DESCRIPTIVE REPORT

Job No. PH-7004 Map No. TP-00167

REVIEW REPORT TP-00167

ADDENDUM TO REVIEW REPORT

COMPARISON PRINT

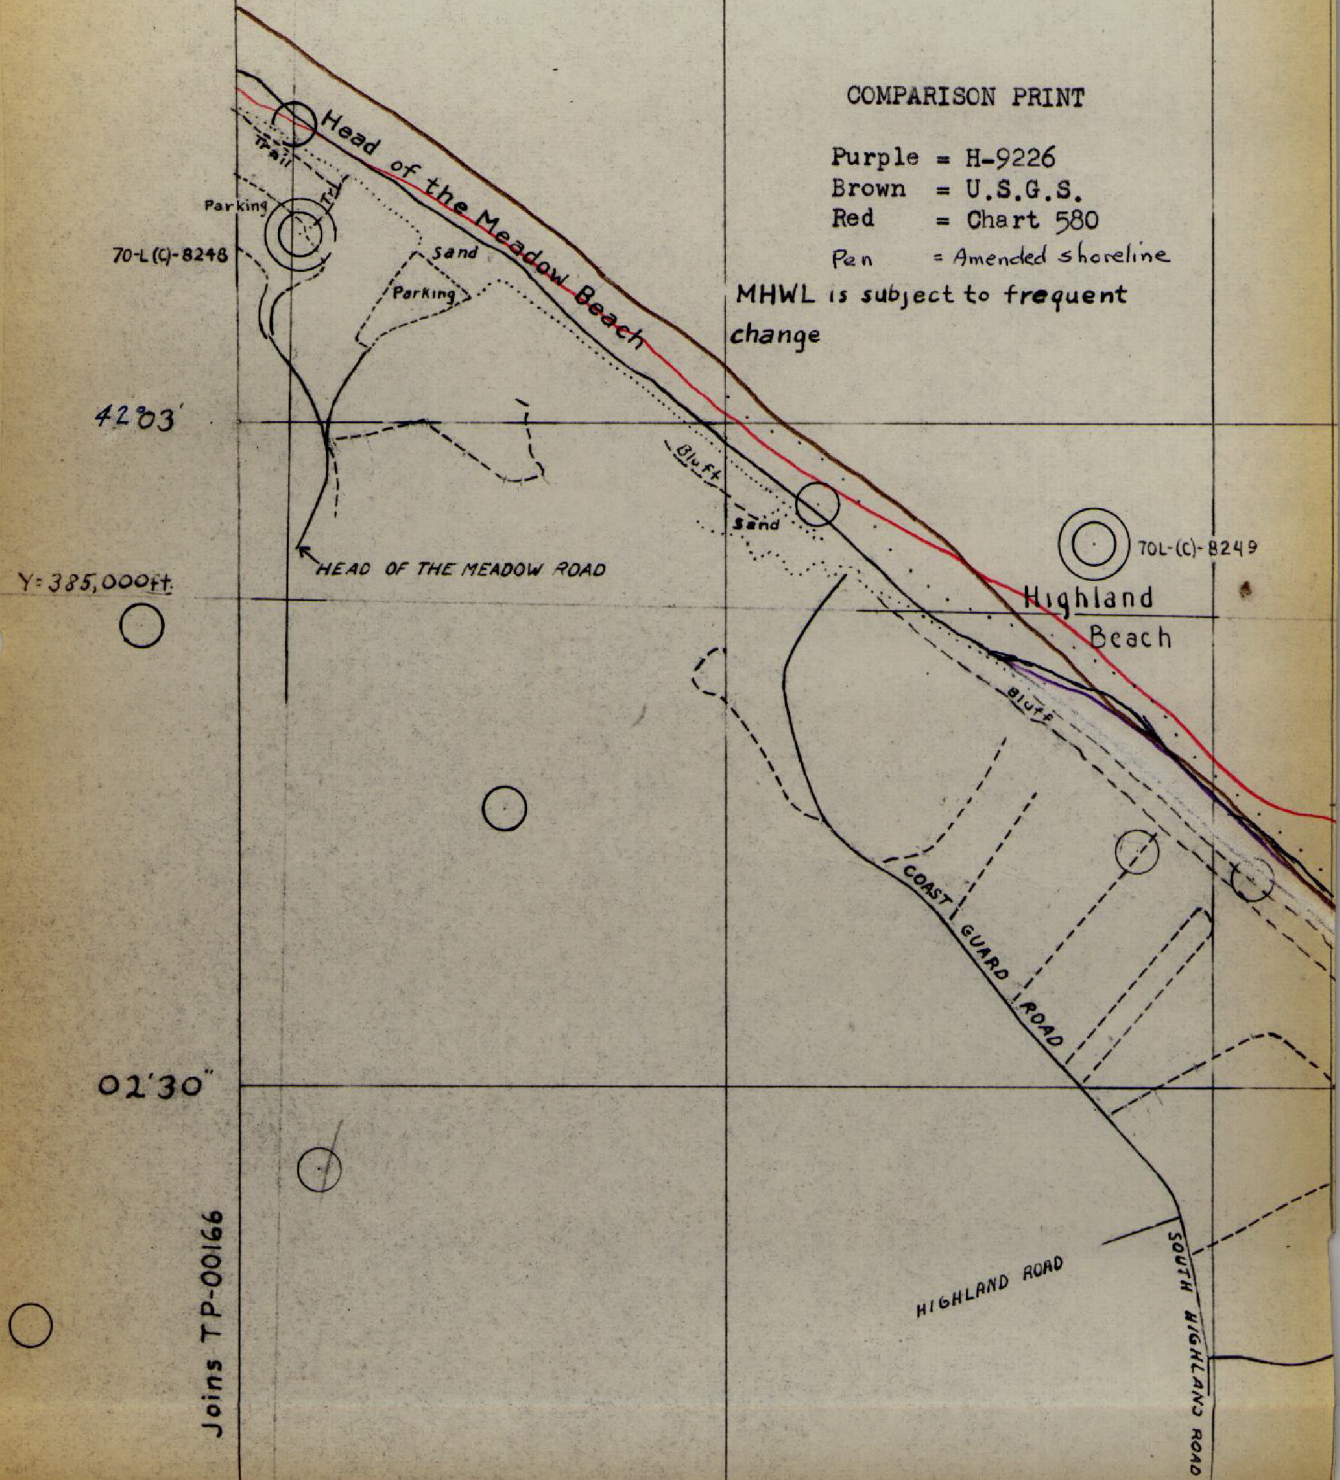
A comparison was made with U.S.G.S. Quadrangle NORTH TRURO, MA, scale 1:24,000, dated 1958. The shoreline on the quadrangle was generally offshore from the shoreline on TP-00167. Shoreline differences between the two maps were shown in brown on the comparison print.

A comparison was made with Boat Sheet H-9226 (PE-20-1-71). There were some discrepancies in the mean high water line. The hydrographer's source of this feature was the Incomplete Manuscript.

The mean low water line was removed from Long. 70°04'30" to the west edge of the map: It was disproved by soundings. The remaining mean low water line was retained — it was in fair agreement with the boat sheet.

The measurements to the MHWL, supplied by the field editor, were too widely spaced to up-date the entire shoreline and produced an illogical inconsistency. On the advice of Rockville Quality Control Authority the shoreline was re-delineated to conform to its location as of the date of photography. *Adjusted shoreline appears on the comparison sheets in ball point pen.*

COMPARISON PRINT

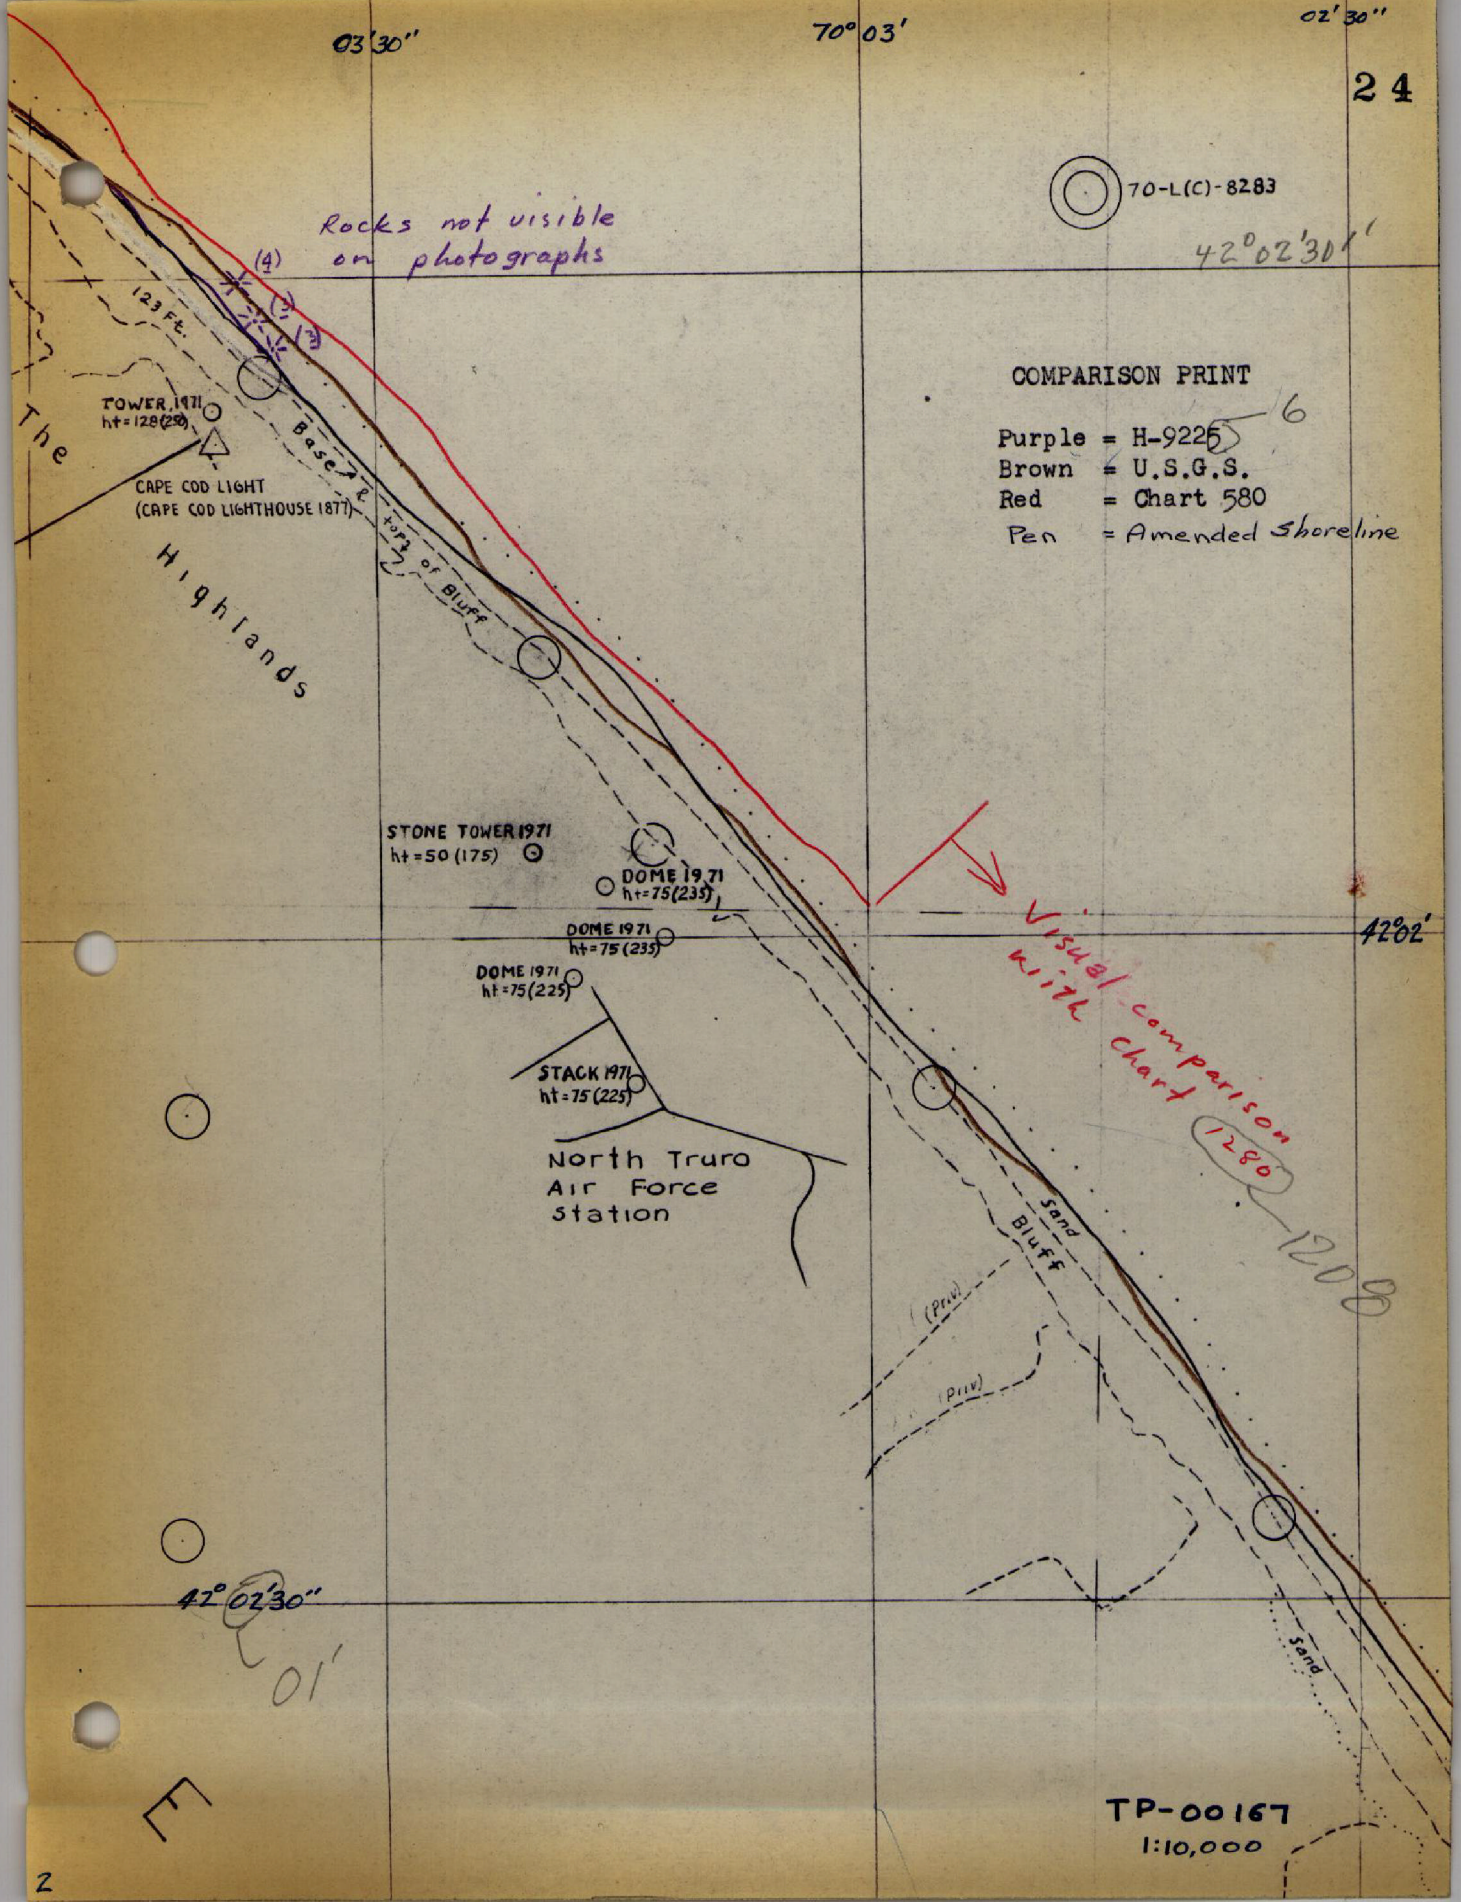
Three rocks at Lat. 42°02'30", Long. 70°03'30" were not visible on photographs of the area and were not mapped on TP-00167. Differences between H-9226 and TP-00167 were shown in purple on the comparison print.

A visual comparison was made with Chart 1208, 1:80,000 scale, 17th edition, dated October 21, 1972. Shoreline was in good general agreement. The only discrepancy noted was the charted landmark (FLAG-POLE) at Lat. 42°00'52", Long. 70°02'06". This landmark was recommended for deletion by the field editor because it is inconspicuous and was not mapped on TP-00167. A new object near by, not yet charted, was recommended for charting and was mapped on TP-00167. See Form 76-40.

Rocks not visible on photographs
